PRELIMINARY DRAINAGE REPORT

GRANDVIEW RESERVE FILING NO. 1

DATE:
September 09, 2022

PCD Filing No.: PUDSP2110

FIGURE 5

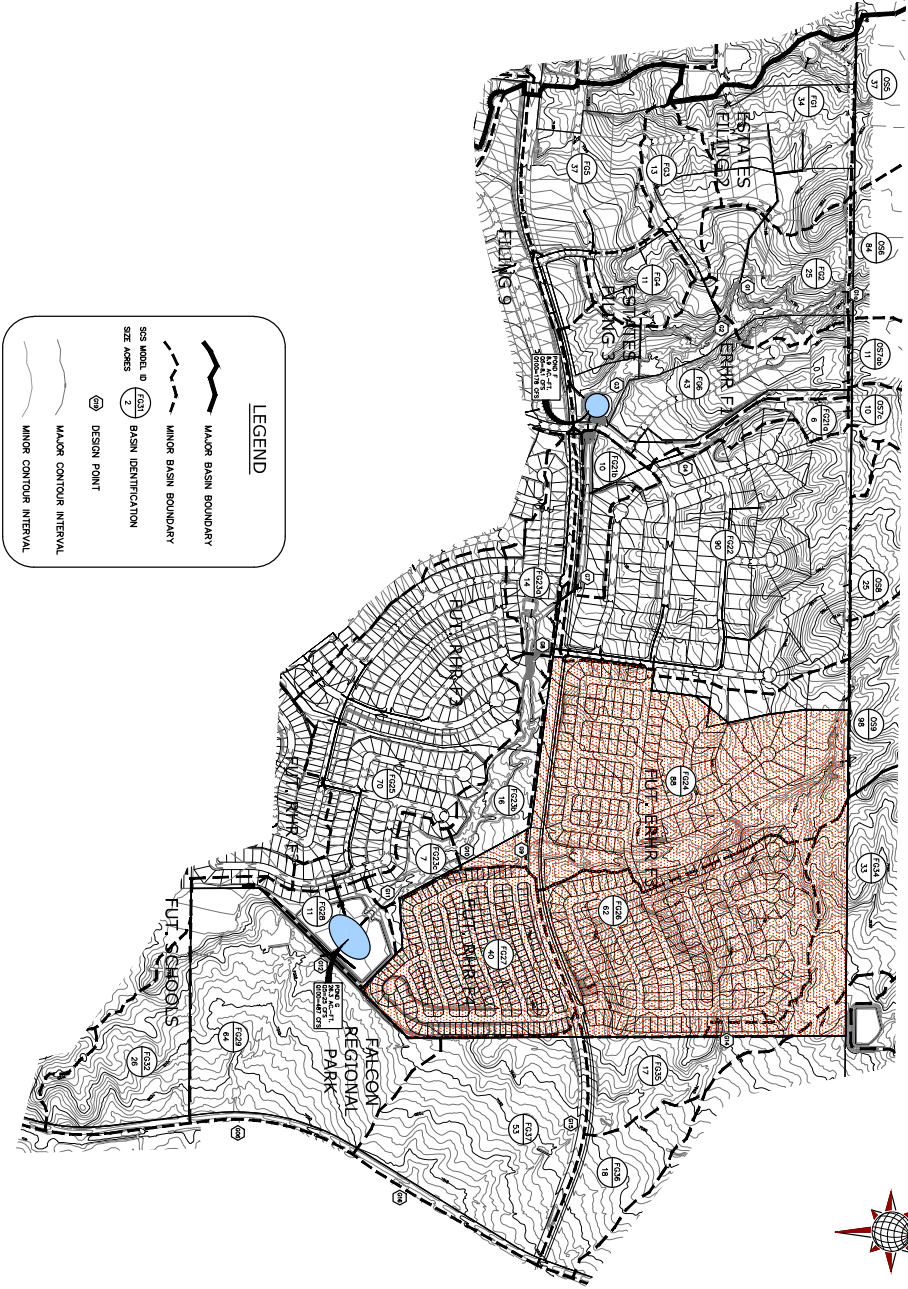
Please only include one set of each item in these appendices. Add a note to the appendix title sheet of whichever is deleted to see the other set in the other report appendix.

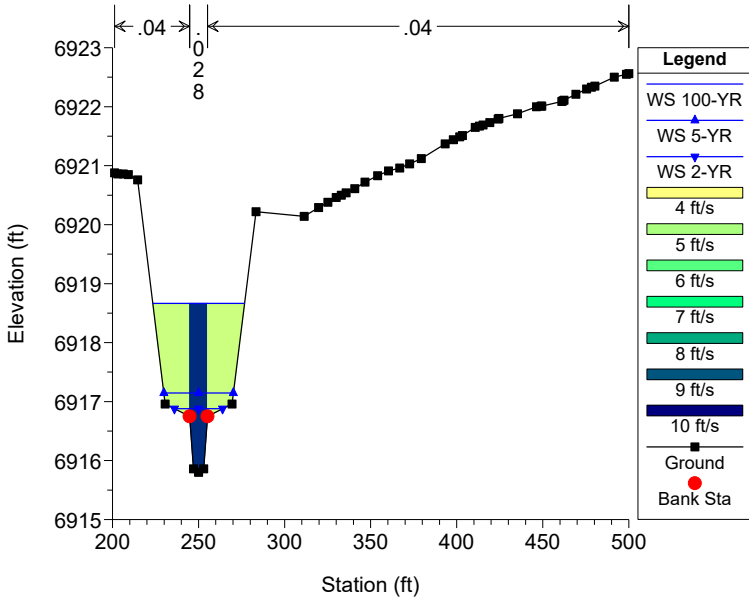
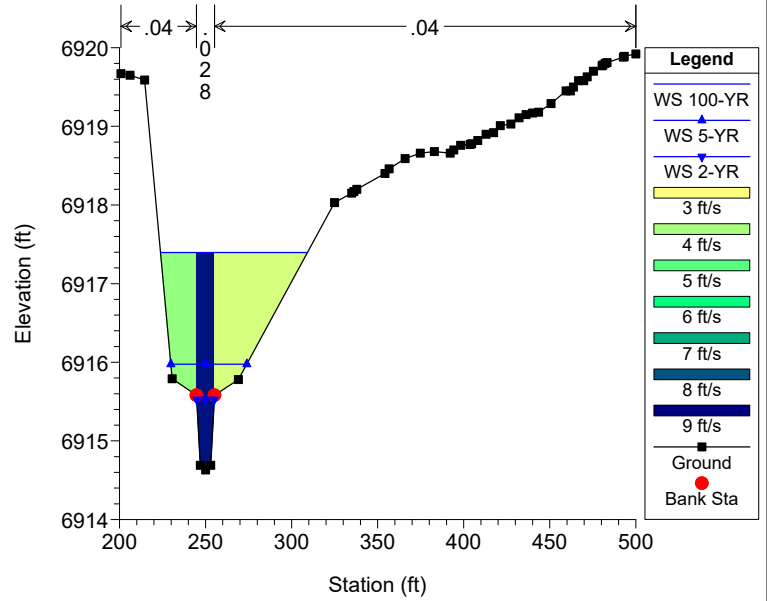
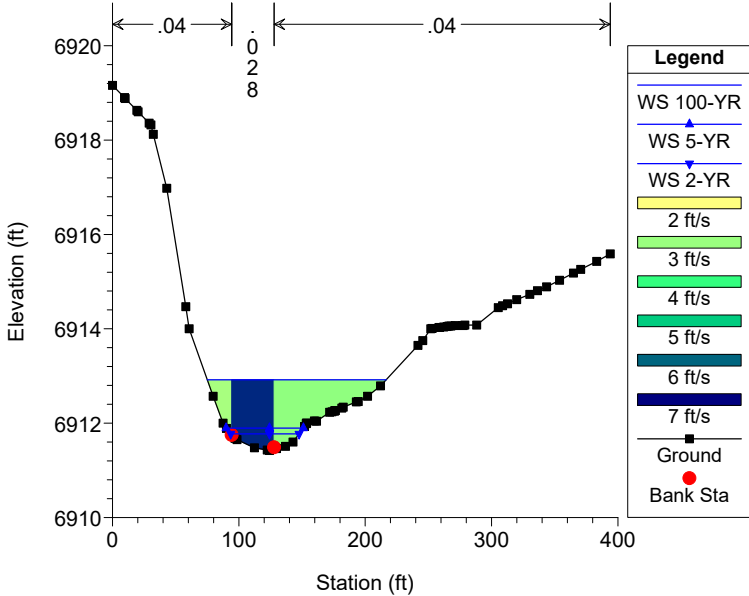
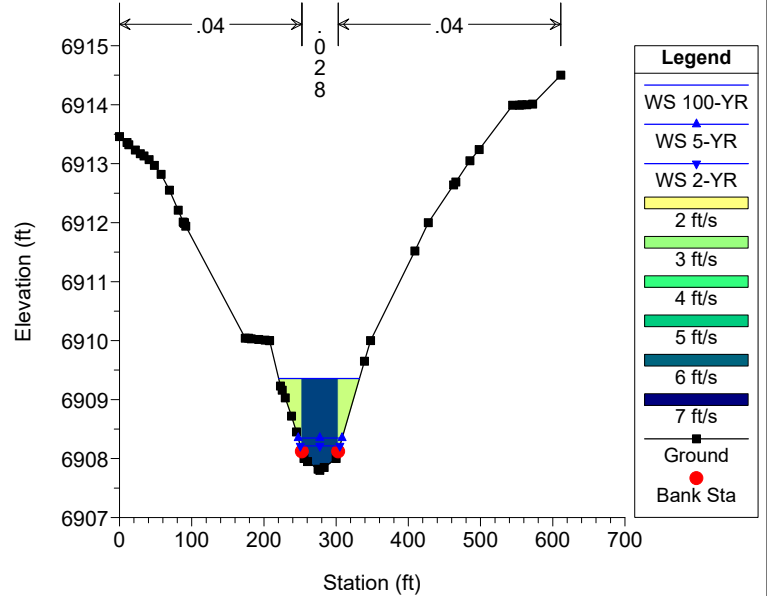
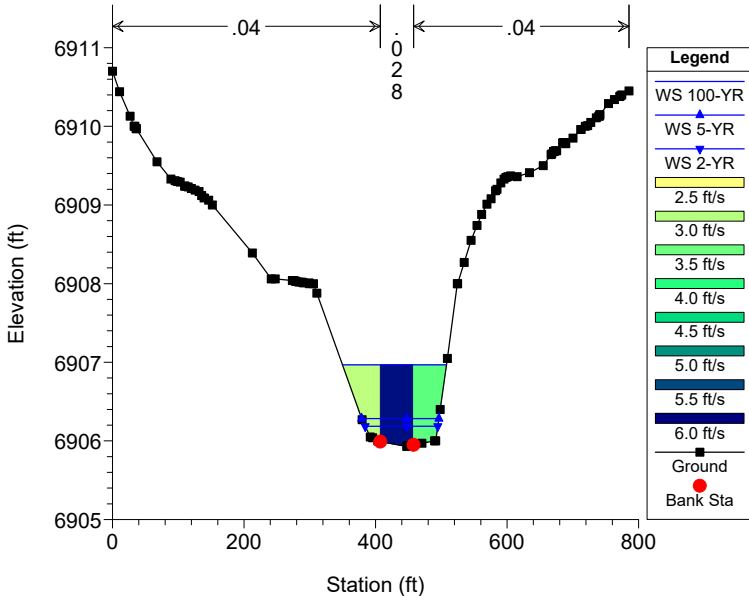
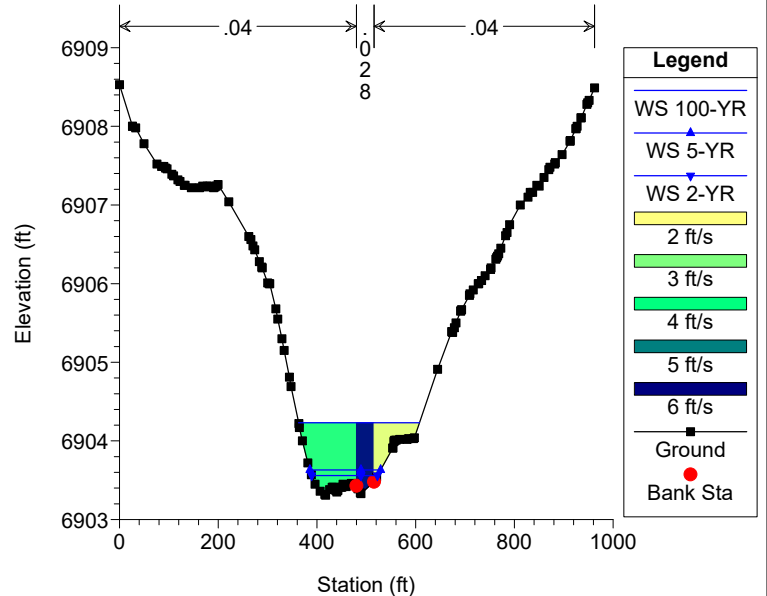
Provide HEC-RAS summary tables somewhere in the PDR
